**Economic and Social Council**Distr.: General
2 December 2016

World Forum for Harmonization of Vehicle Regulations**Working Party on Noise****Sixty-fifth session**

Regulation No. 51 (Noise of M and N categories of vehicles):**Additional sound emission provisions****Proposal for Supplement 2 to the 03 series of amendments to
Regulation No. 51****Submitted by the Informal Working Group on Additional sound
emission provisions***

The text reproduced below was prepared by the Informal Working Group (IWG) on Additional sound emission provisions (ASEP) to update and revise the 03 series of amendments to Regulation No. 51. The proposed amendments to the current Regulation are marked in bold for new or strikethrough for deleted characters.

Figure 1
Flowchart for the assessment concept for ASEP according to Annex 7

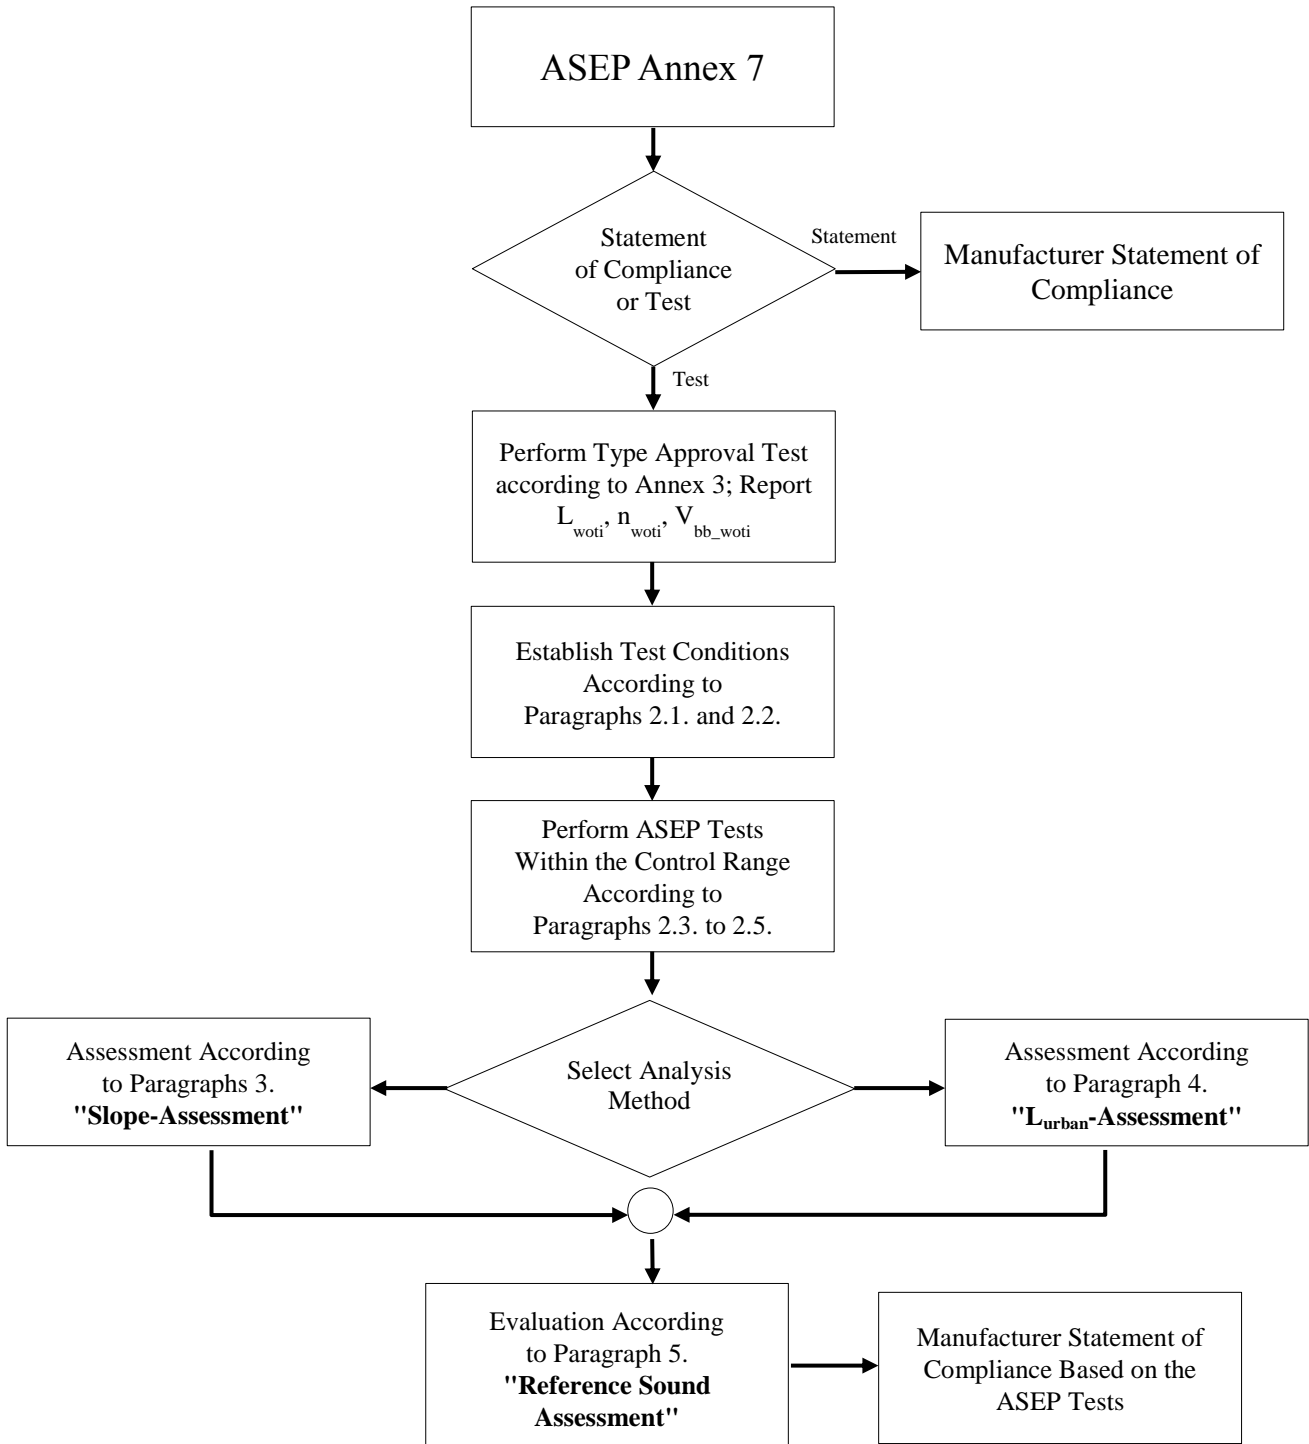
- 1.12. Flowcharts were introduced.
2. To facilitate reading and understanding, the text was re-structured.
 - 2.1. Some paragraphs were renumbered.
 - 2.2. The sentences of paragraph 2.4. were moved to paragraphs 2.3. and 2.5.1.
